Response to Recommendations to the CDR Submission for 1601 Washington Avenue

August 9, 2024

Licenses and Inspections Application Number: ZP-2024-005030

Project Address and/or Title: 1601 Washington Avenue

2 WASHINGTON AVENUE ELEVATION
SCALE: 1/32"= 1'-0"

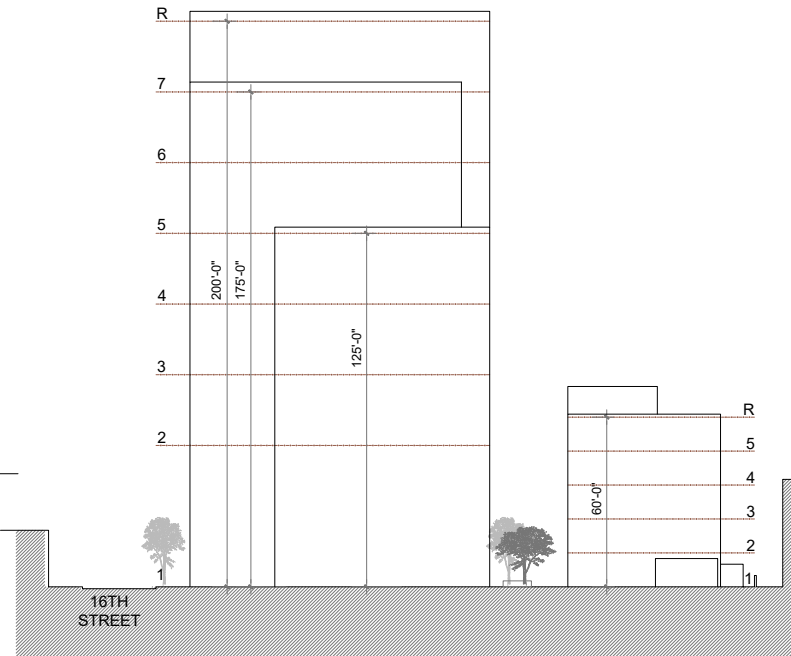
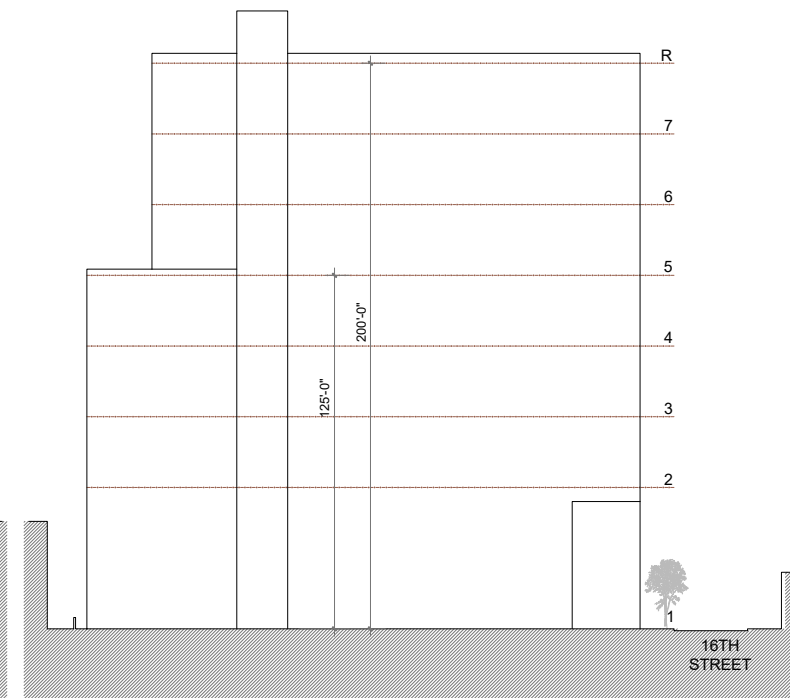
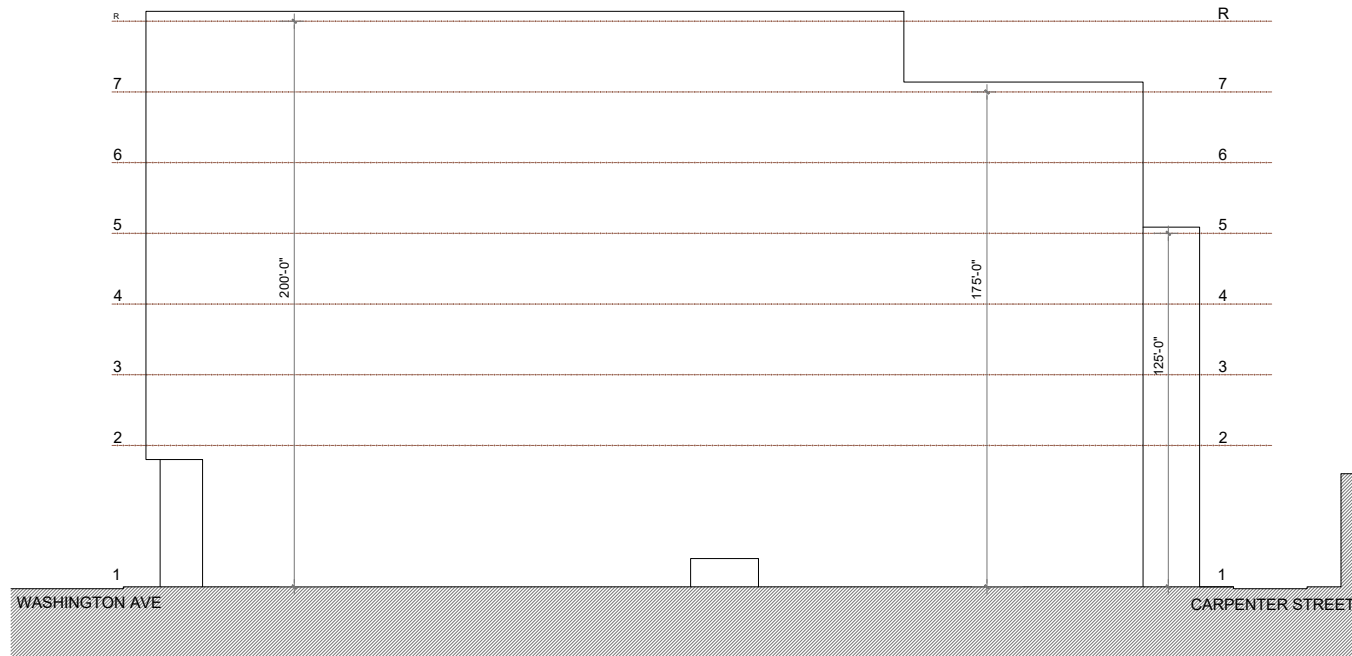
1. Concerns that building looks residential in character. If intent is to build residential, then that residential project is what the CDR Committee should be reviewing. *Noted.*

2. Building will be highly visible. For its proposed use as shown (urban agriculture), current design is missed opportunity to highlight what could be innovative landmark project. Consider maximizing transparency and greenery, including at ground level. *Noted.*

- Consider extending 60' building height on partial side of west façade to entire west façade. *To be considered.*
4. Consider how recessed entryways at 16th & Washington and 16th & Carpenter can be designed more intentionally as small plazas, with programming. *To be considered.*

1 1ST FLOOR PLAN W/ LANDSCAPE PLAN
SCALE: 3/64" = 1'-0"

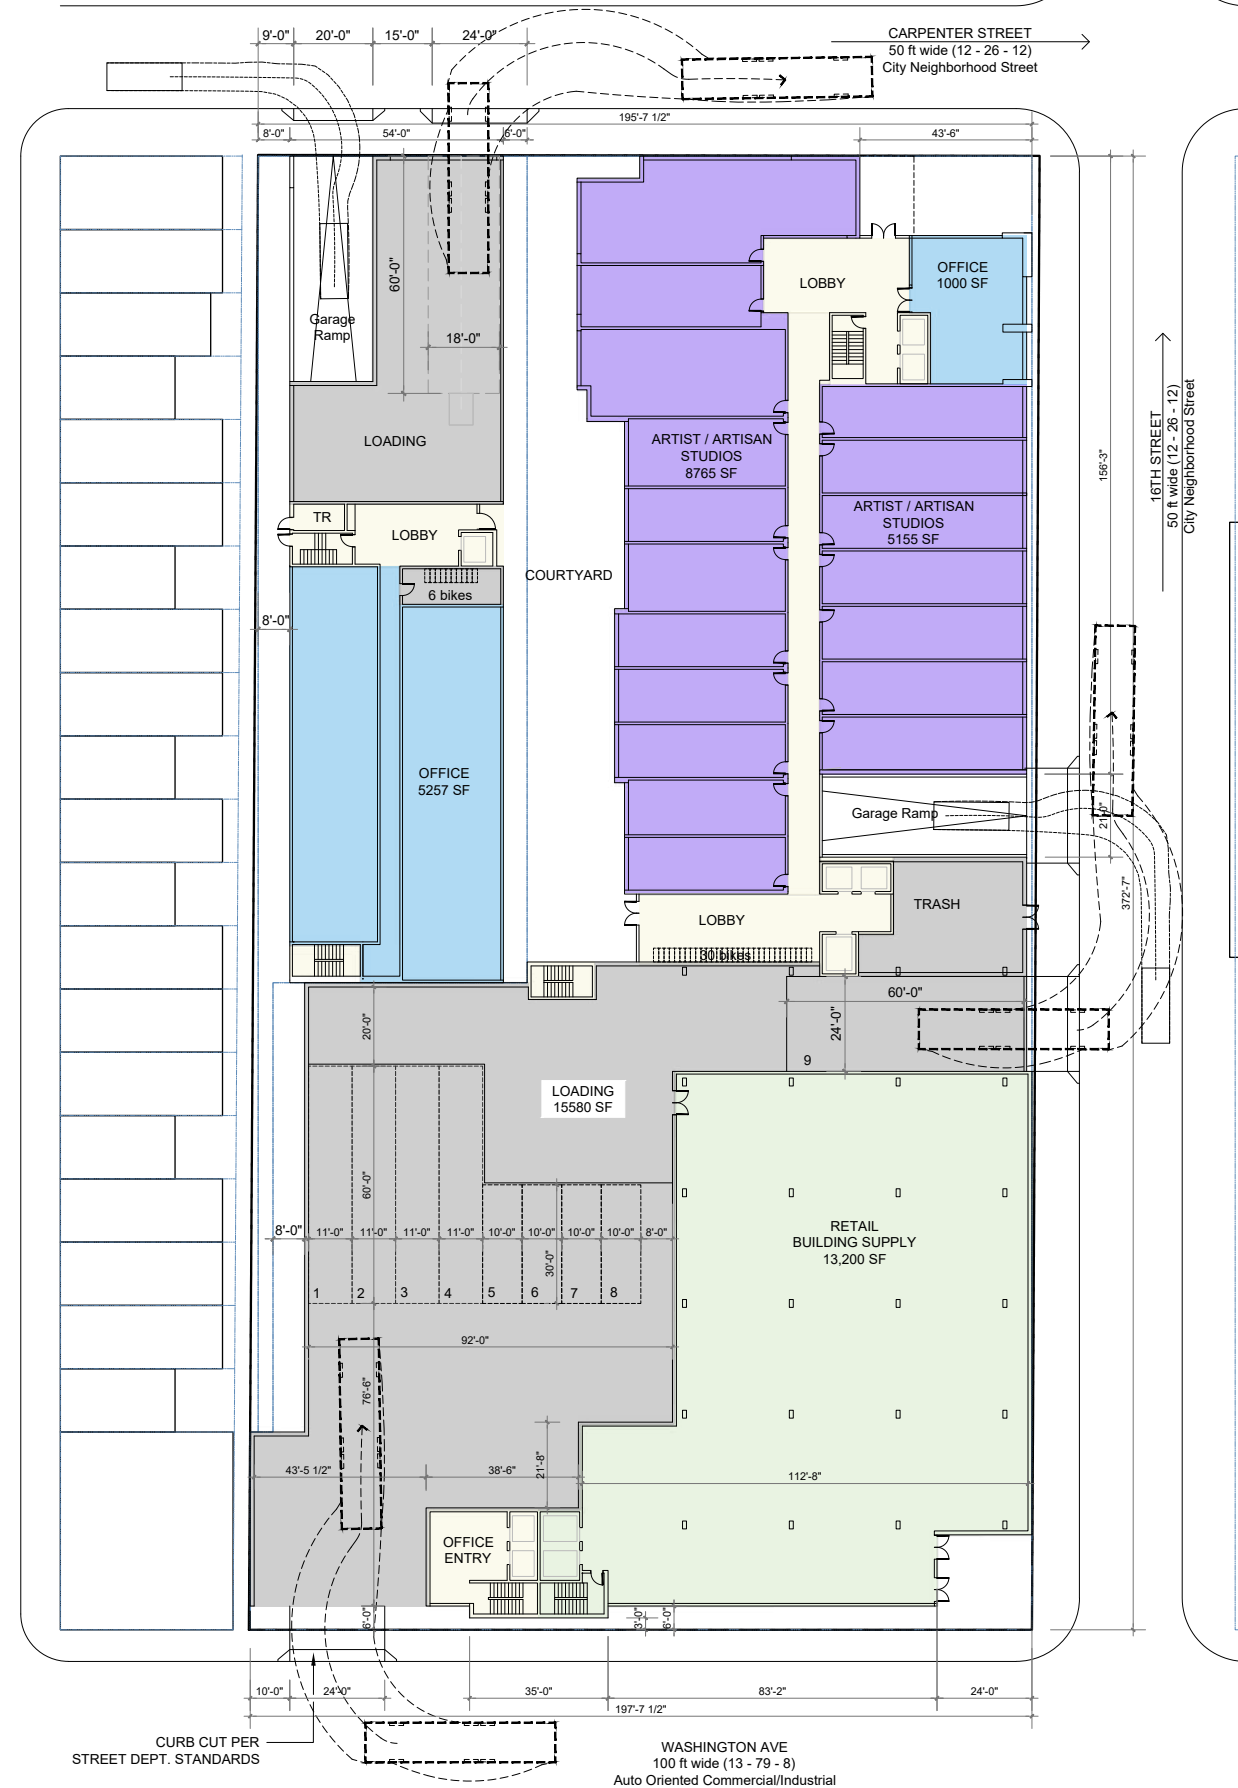
1. Concerns about excessive number of curb cuts and ground floor space dedicated to loading. Consider eliminating curb cuts on Washington Ave. (and/or Carpenter St.) and consolidating loading zones. *Loading docks will be re-evaluated.*

3. Expand bike room to accommodate bike parking currently located in lobby. *To be revised.*
4. Add exterior bike racks for visitors. *To be added.*
5. Consider adding raised bike lane on Washington Ave. (existing bike lane currently not protected).
The viability of this proposal is to be evaluated.

6. Concerns about missed opportunity for welcoming gathering space open to artists, urban farmers, and potential visitors.
 - Consider enlarging lobby on 16th & Carpenter. *To be considered.*

- Consider relocating courtyard to be in-between artist studios. *To be considered.*
 - Consider relation of 2nd story courtyards to ground-floor courtyard and maximizing connectivity between these potential shared spaces. *To be considered.*

1. Concerns about lack of vehicular circulation in underground parking area.
 - Consider more circular layout to minimize dead end conditions. *The parking was designed to optimize the balance of circulation and the required number of parking spaces.*
 - Consider combining parking areas underneath Parcels A and B to provide for more design flexibility to improve circulation *To be considered.*
